REMARKS

In the Official Action mailed 5 May 2005, the Examiner reviewed claims 1-27. The Examiner objected to the drawings; objected to the specification and rejected claims 1-27 under 35 U.S.C. §102.

FIG. 1

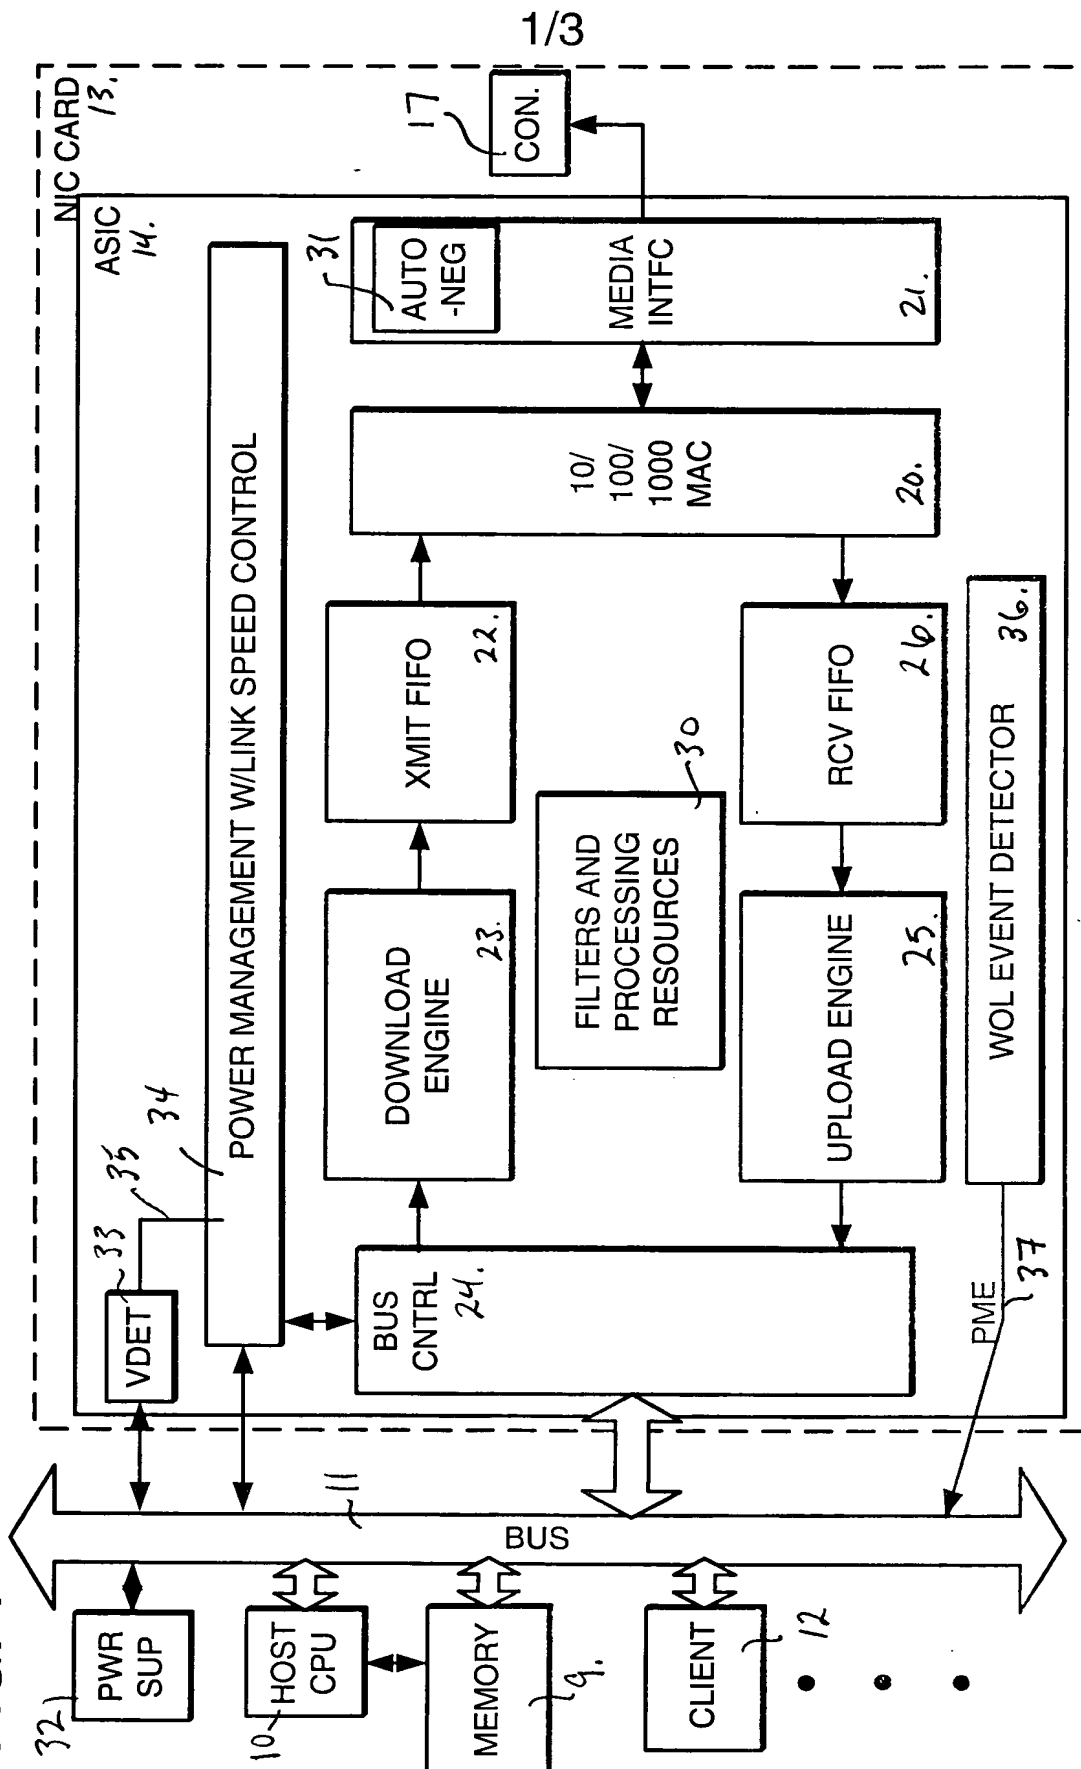
The Examiner has objected to Figure 1 because the connector is not labeled. Reference number 17 has been added to the connector in Figure 1. Replacement sheets are attached to this Response.

The attached sheets of Replacement Sheets and Annotated Sheets Showing Changes in the Appendix include changes to Figure 1. These sheets replace the original sheets including Figures 1-2B as filed. In Figure 1, the reference number 17 has been added to the connector.
